# MEMO

**To:** Kristopher Byrd, Well Construction and Compliance Section Manager  
**From:** Travis Kelly, Well Construction Program Coordinator  
**Subject:** Review of Water Right Application G-19002  
**Date:** December 11, 2020

# Groundwater Application Review Summary Form

Application # G- 19002

Steve Coleman - Gary Baker  
 Cable Tool Drilled Well  
 as proposed to be  
 Completed July 26, 1982

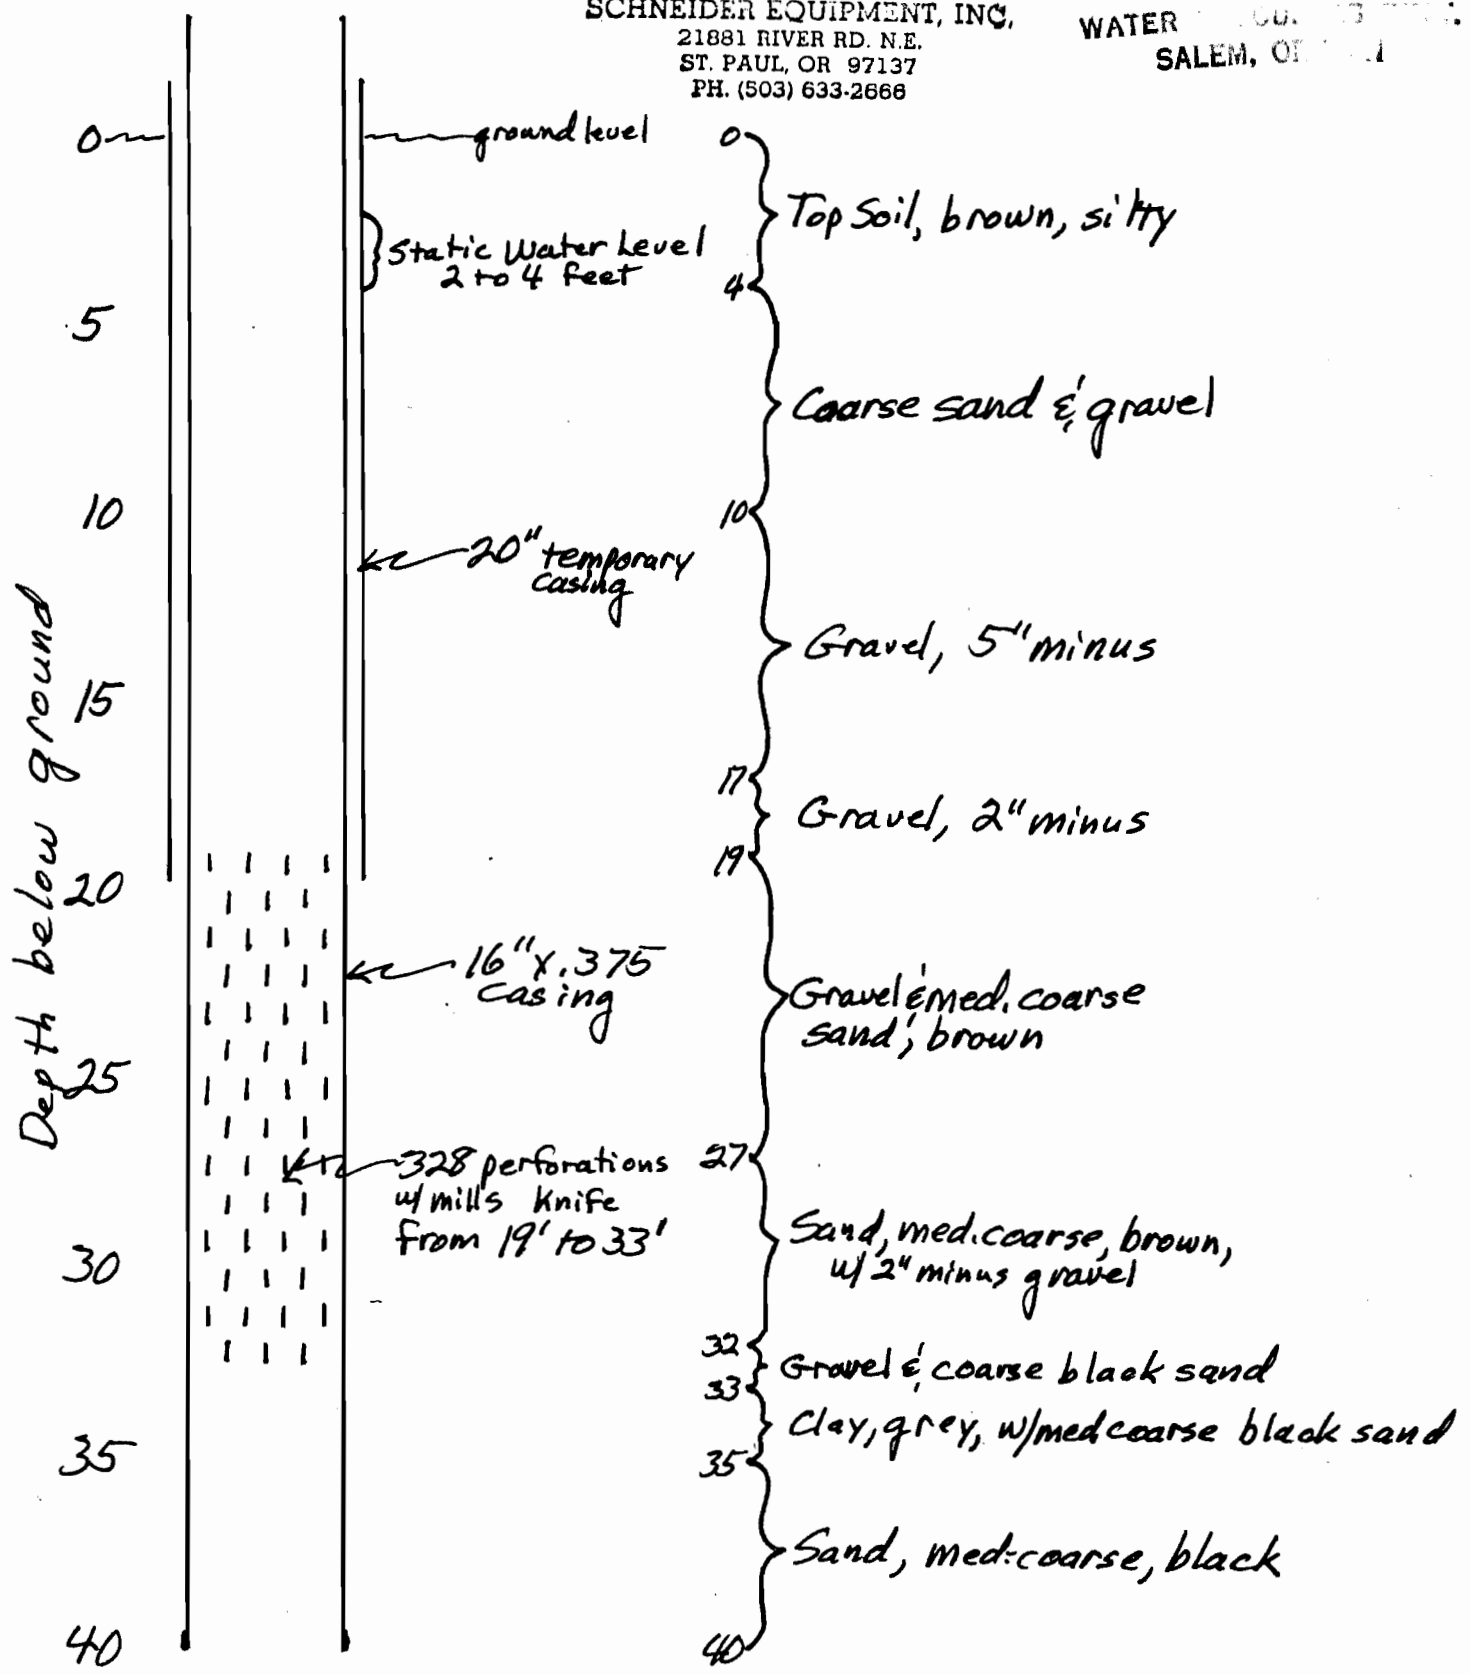
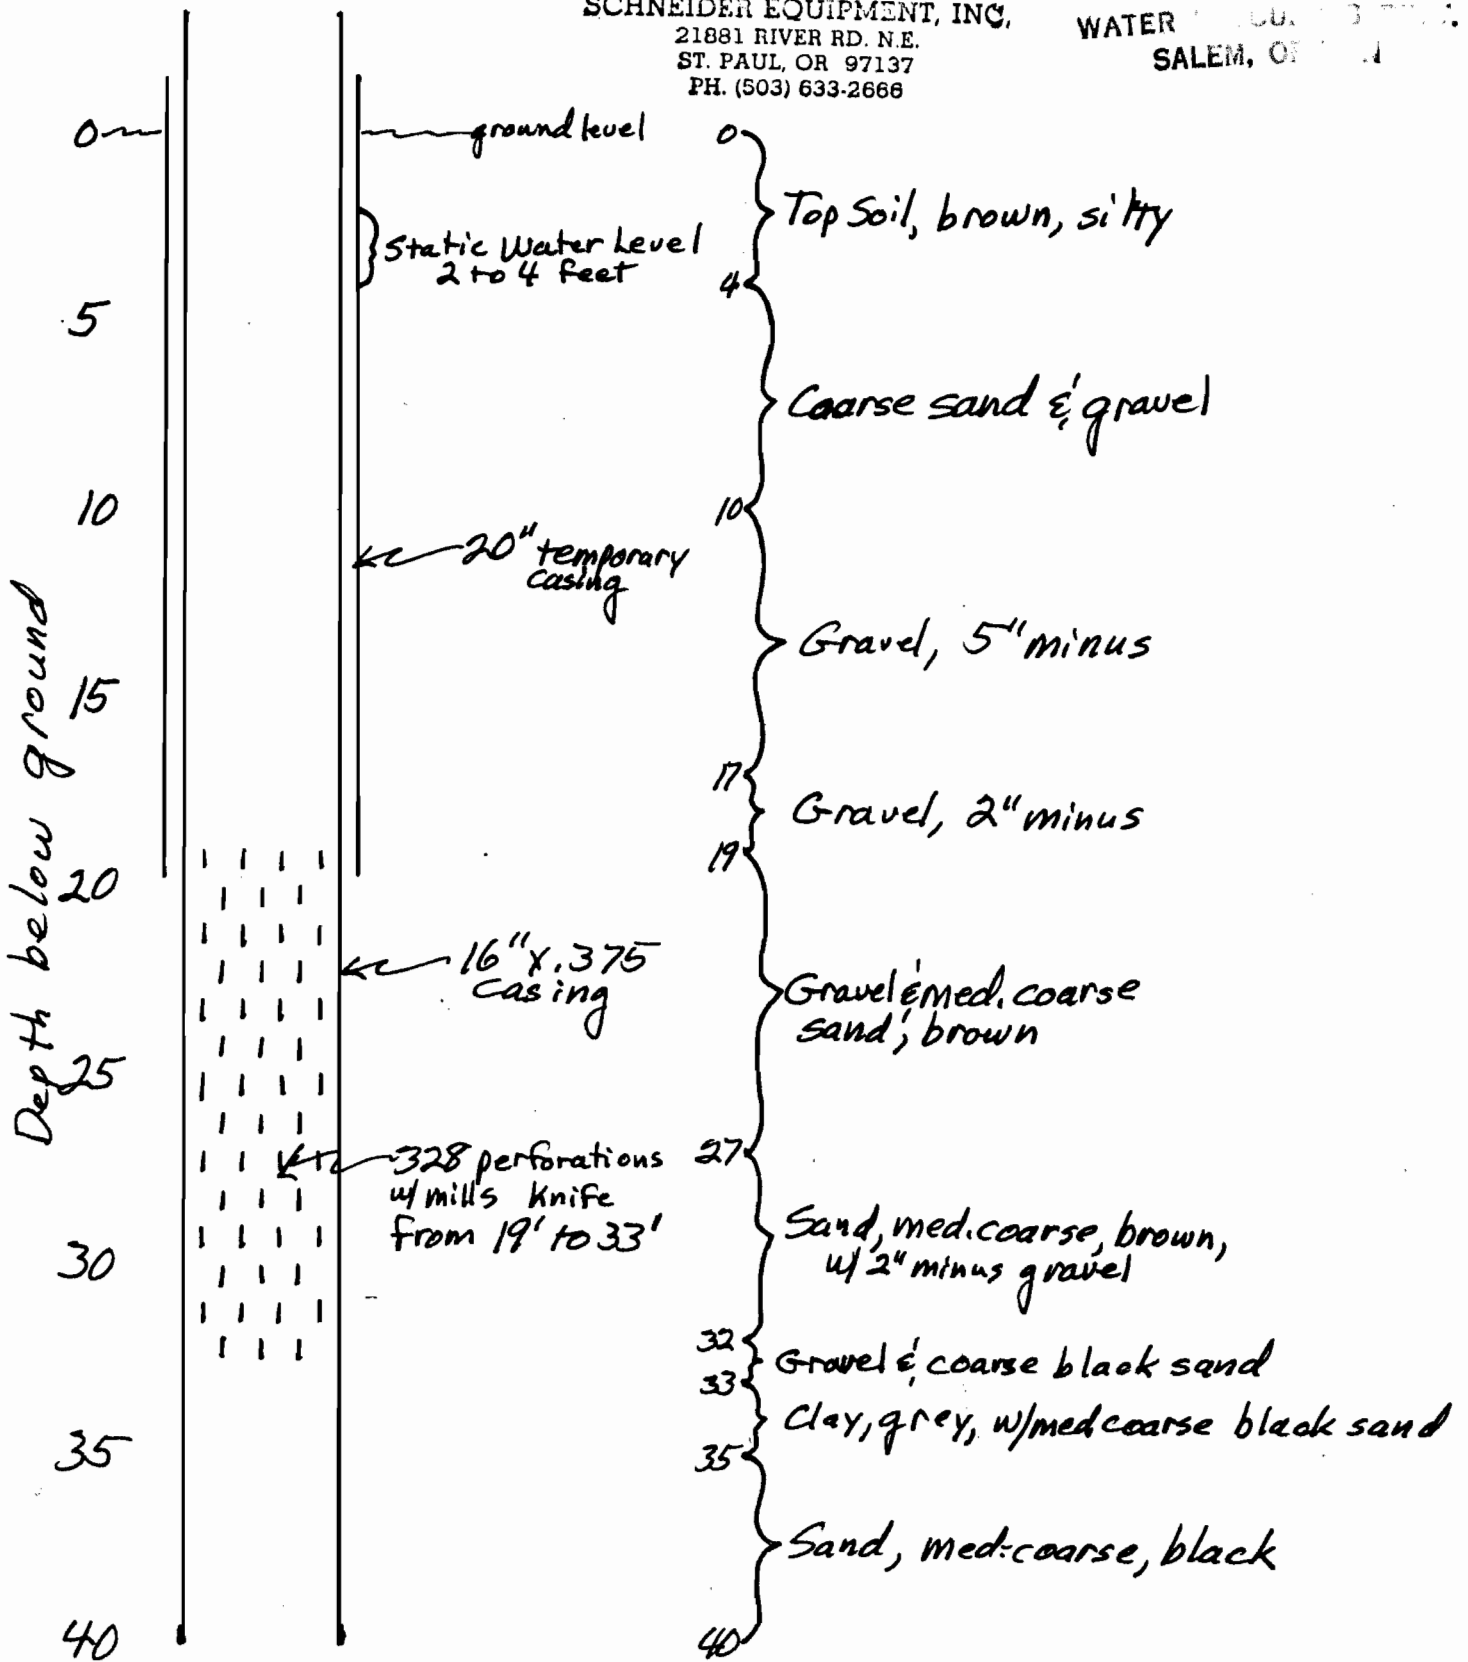
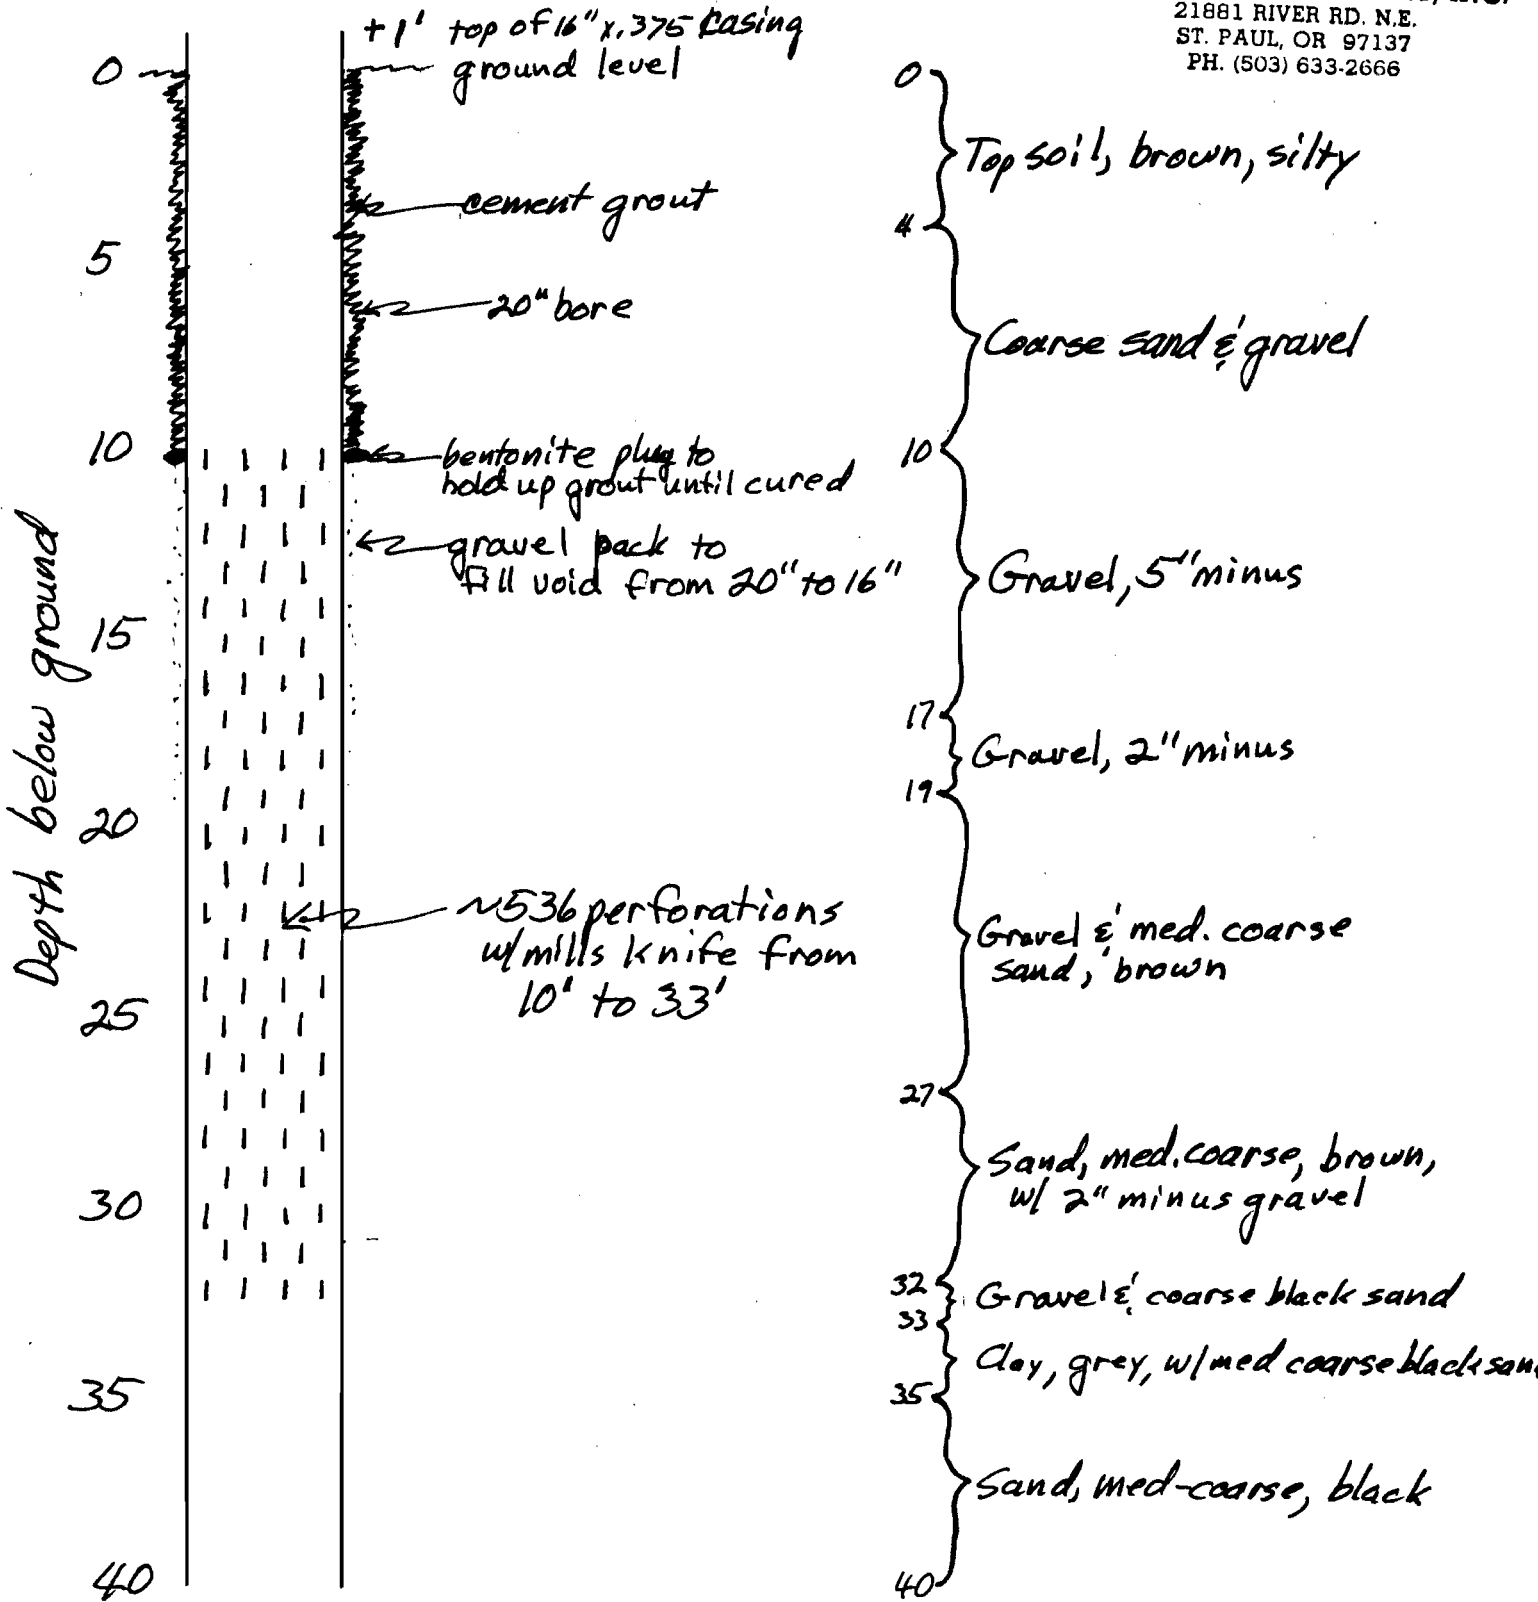
As discussed with you by phone on July 22, 1982, we are drilling an irrigation well for Mr. Steve Coleman (renter), c/o Mr. Gary Baker (owner), 21880 S.W. Farmington Rd., Beaverton, OR 97005. The well is located in Marion County, NW  $\frac{1}{4}$  of NE  $\frac{1}{4}$  of Section 11 T5S, R3W. No septic tanks or drainfields, Or other wells are known to be within approximately 1000 feet of this well. A copy of formations penetrated is attached along with a sketch of the well as constructed to date. The customer has test pumped the well and is not satisfied with the yield and pumping level. It is therefore desired to additionally perforate the well from 19 feet to 10 feet since this zone contains some of the best water bearing formation penetrated. Note that the static of the well varies from 2 to 4 feet below ground and appears to fluctuate very closely to the level of the Willamette River, which is understandable considering the well is located less than 50 feet from a ditch connected to the river. Considering the extremely low level of the river at this time, if we perforate no higher than 10 feet, we will still be over 5 feet below the mean water level. A sketch of the proposed final construction is attached.. Please confirm that the proposed construction is acceptable.

This letter is to grant the special standards you requested in your letter of July 26, 1982, for the Coleman-Baker well located in the NW 1/4 NE 1/4 of Section 11, Township 5 South, Range 3 West in Marion County.

Given the condition described in the letter, it is acceptable to seal this well to five feet below the mean summer flow of the Willamette, or 10 feet from land surface.

**Stream Depletion: Well 1 to Willamette River**

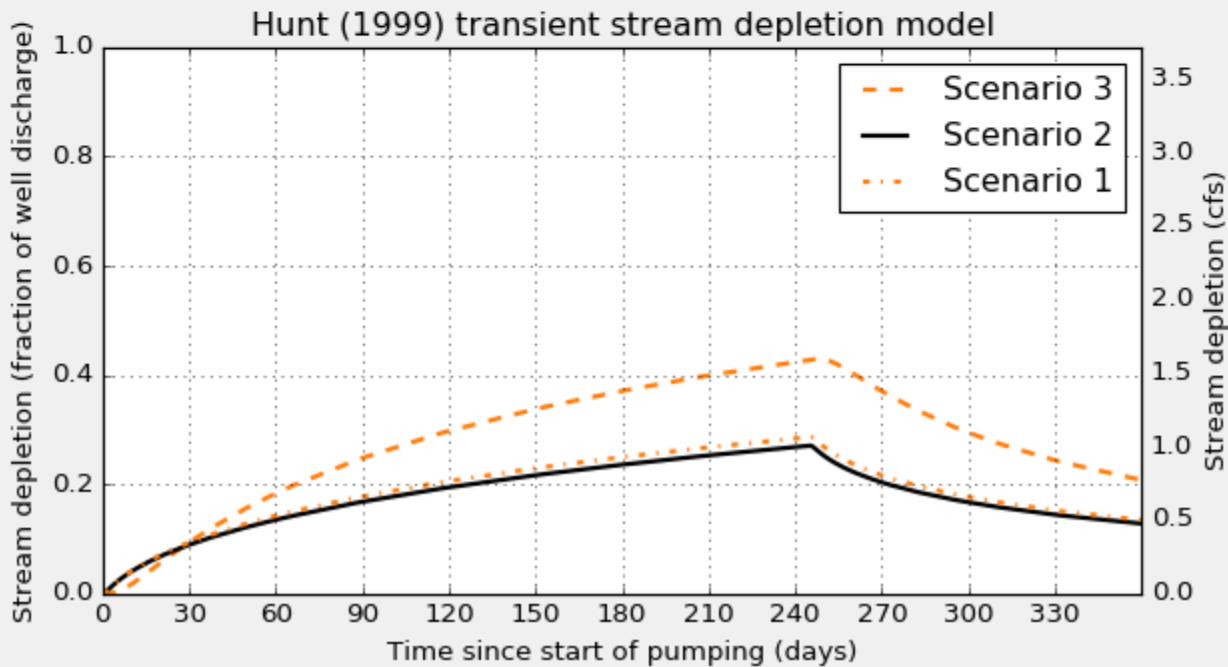
**Comments:** Interference with various surface water sources due to the proposed use was quantitatively estimated using the Hunt 1999 analytical model for Wells 1 & 3, and the Hunt 2003 analytical model for Well 2. Hydraulic parameters used for the analysis were derived from regional data and studies (Conlon et al., 2005). Results indicate that none of the proposed POA are anticipated to interfere with nearby surface water sources at a rate greater than 25 percent of the rate of withdrawal within the first 30 days of continuous pumping.

**Well 1, MARI 2892**

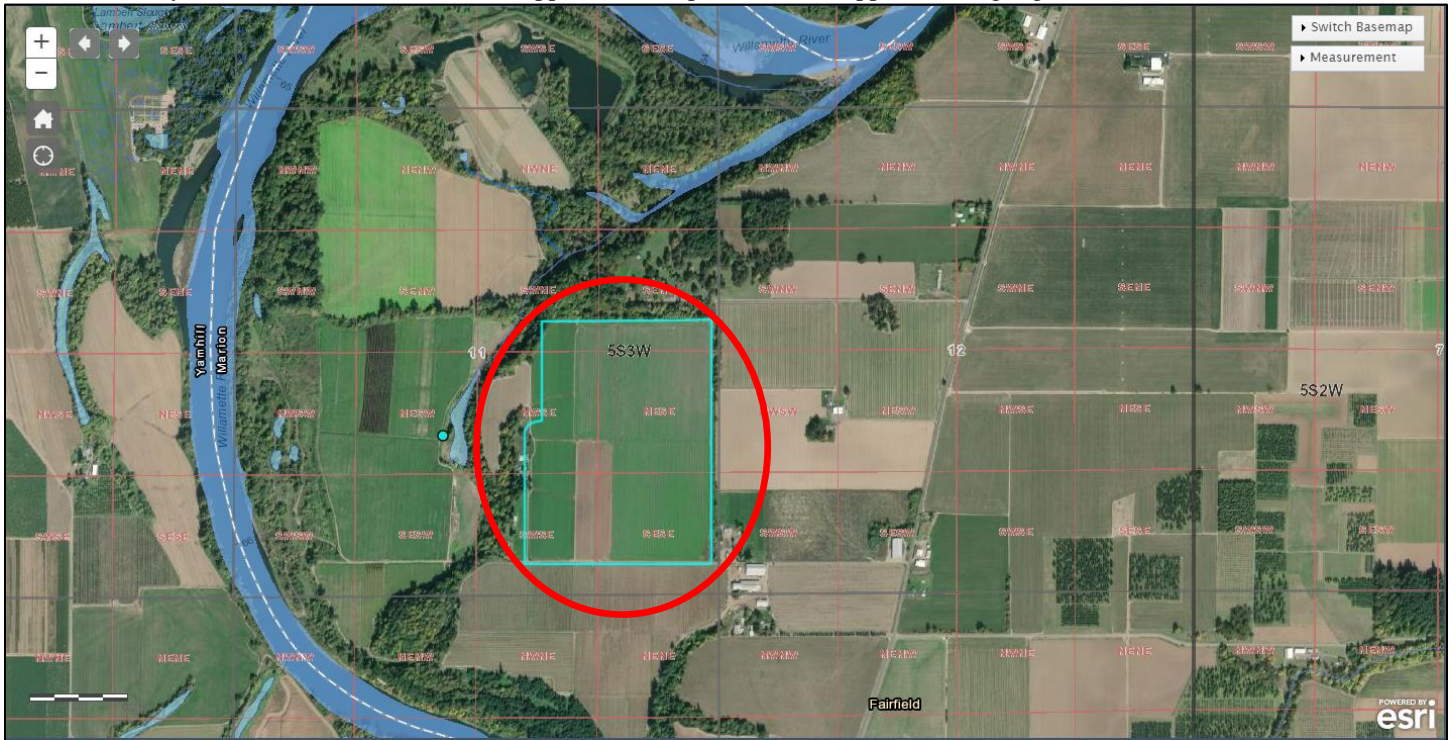
Well 1 (MARI 2892) is authorized for 1.44 cfs for irrigation of 114.9 acres under Certificate 43676 owned by Opal M Mahony. It appears that the 114.9 acres irrigated under Certificate 43676 are proposed as nursery use from wells 1 & 2 under this application. Well 1 is also authorized for 0.04 cfs for irrigation of 9.5 acres under Certificate 75639 owned by Michael W Mahony. This groundwater review evaluates against a stacked rate of 3.71 cfs.

**Well 2, MARI 2900**

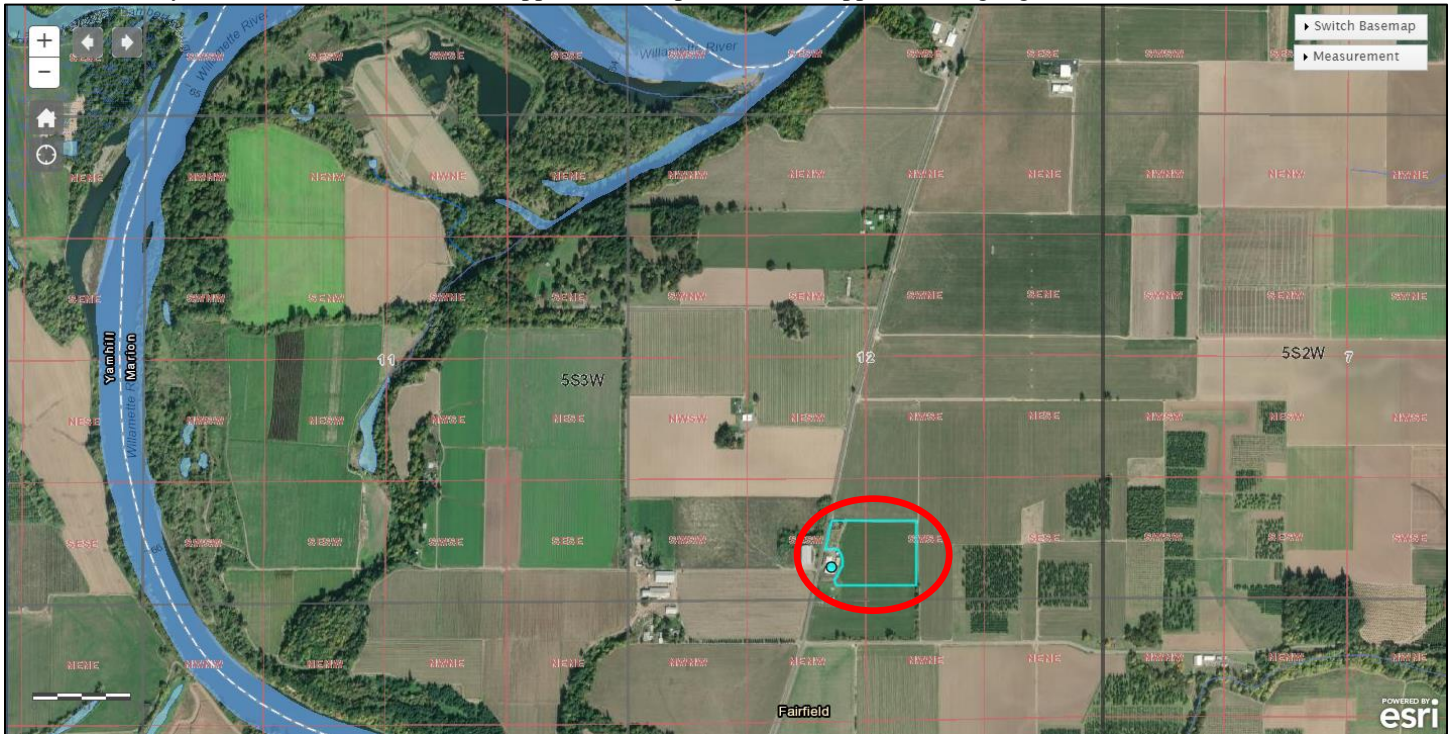
Well 2 (MARI 2900) is authorized for 0.18 cfs for irrigation of 14.2 acres under Certificate 55955 owned by John Stockfleth. It appears that the 14.2 acres irrigated under Certificate 55955 are proposed as nursery use from wells 1 & 2 under this application. This groundwater review evaluates against a stacked rate of 2.41 cfs.
